TOWN OF TIBURON
Tiburon Town Hall
1505 Tiburon Boulevard
Tiburon, CA 94920

Regular Meeting
Design Review Board
November 2, 2016
7:00 p.m.

1. 85 EAST VIEW AVENUE

Subject: 85 East View Avenue; File Nos. DR2016091, VAR2016026, VAR2016027, VAR2016028, VAR2016029, VAR2016030 & FAE2016009 ; Site Plan and Architecture Review for Construction of a New Single-Family Dwelling, with Variances for Reduced Front and Side Setbacks, Excess Lot Coverage and Excess Building Height, and a Floor Area Exception (Continued from September 1, 2016)

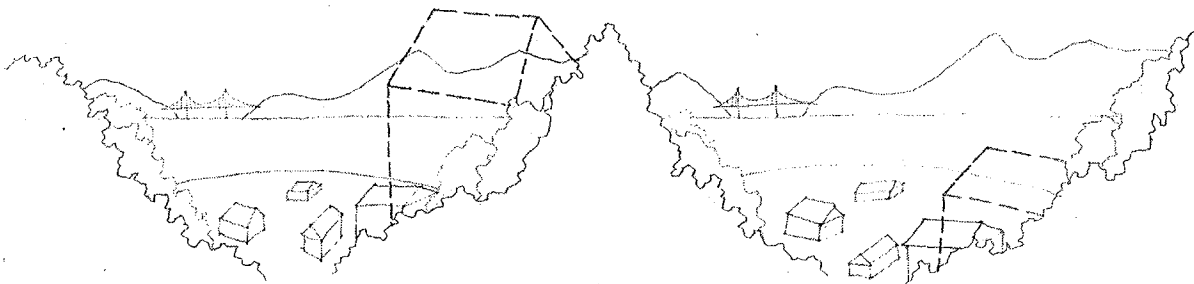
Goal 3, Principle 7 (B) of the Hillside Design Guidelines states that the “horizon line is [the] most sensitive part of [the] view, then foreground, then middleground.” The proposed home would be in the foreground view and extend past the horizon line from the home at 83 East View Avenue. The house would be situated in the middleground of the view of the home at 87 East View Avenue.

2. BLOCKAGE OF CENTER OF VIEW MORE DAMAGING THAN BLOCKAGE OF SIDE OF VIEW.

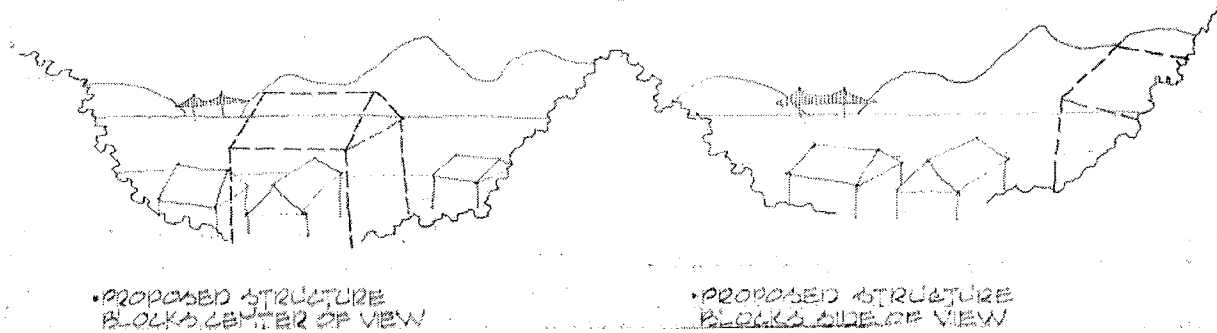
Goal 3, Principle 7 (C) of the Hillside Design Guidelines states that “blockage of center of [the] view [are] more damaging than blockage of [the] side of [the] view.” The proposed house would intrude into the side of the view from the home at 83 East View Avenue, but the center of the view from the kitchen and dining room. The living room of the home at 87 East View Avenue has windows on two sides, with the proposed house sitting in the center of one of the windows.

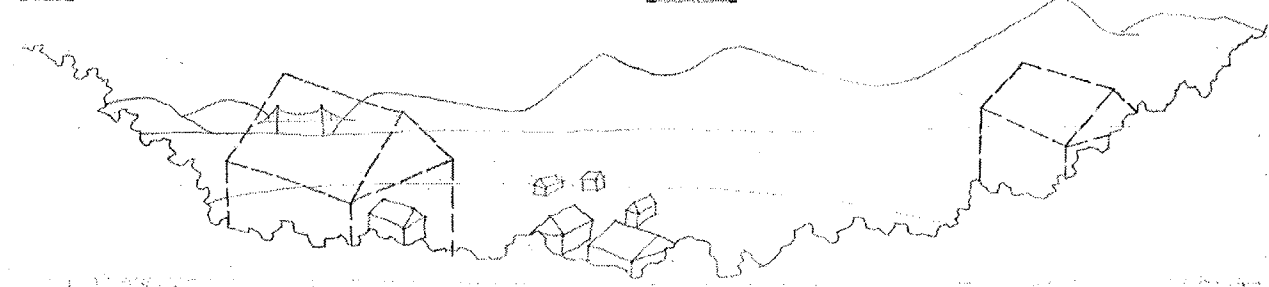
Goal 3, Principle 7 (C) of the Hillside Design Guidelines states that “blockage of important objects in the view (Golden Gate Bridge, Belvedere Lagoon, Sausalito, Angel Island) is more difficult to accept than blockage of other, less well-known landmarks.” The proposed house would block views of Mt. Tamalpais and Belvedere Lagoon from the kitchen and dining room of the home at 83 East View Avenue and would block views of San Francisco Bay and Angel Island from the living room of the home at 87 East View Avenue.

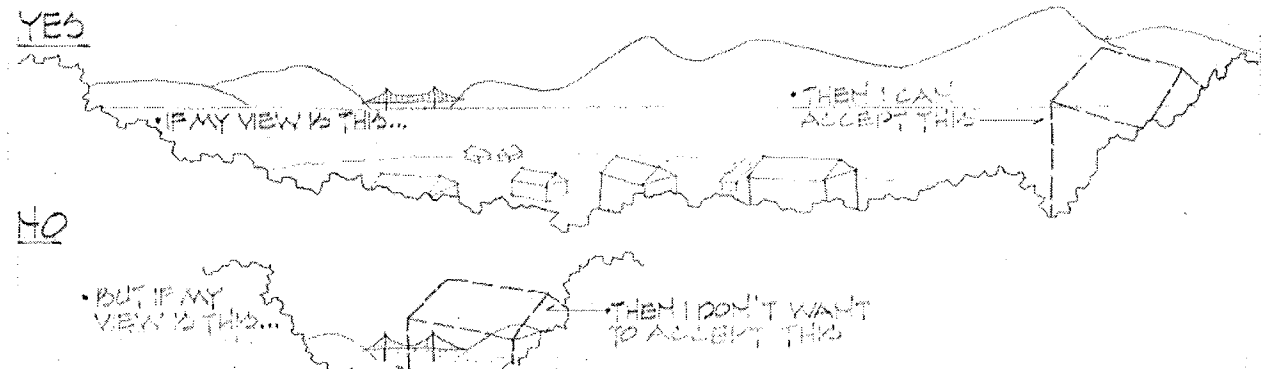
Goal 3, Principle 7 (E) of the Hillside Design Guidelines states that “a wide panoramic view can accept more view blockage than the smaller slot view.” The home at 83 East View Avenue has a relatively panoramic view to the north and west, while the home at 87 East View Avenue has bifurcated views to the east and west.

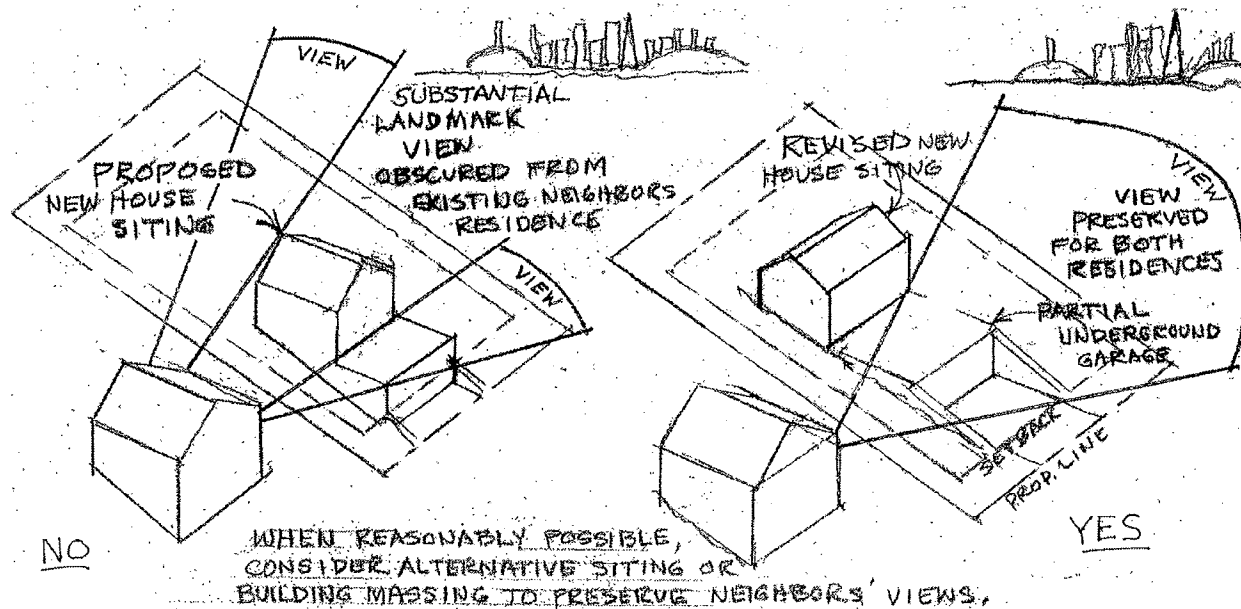
Goal 3, Principle 8 of the Hillside Design Guidelines states that “a view across a vacant lot is often considered to be a ‘borrowed’ view, which is likely to be compromised by the eventual development of the vacant lot. A borrowed view is one which is temporary in nature and which may be reasonably expected to change upon development of the lot. Consideration may be given to preserving portions of a borrowed view if this is the only substantial view for a neighboring home.” The views from the dining room and kitchen of the home at 83 East View Avenue are directly across the subject site and could be considered to be borrowed views. The view from the living room at 87 East View Avenue is currently limited by the home at 83 East View Avenue beyond the subject property and only a portion of the proposed house would extend beyond the other neighboring home and into views toward Angel Island.
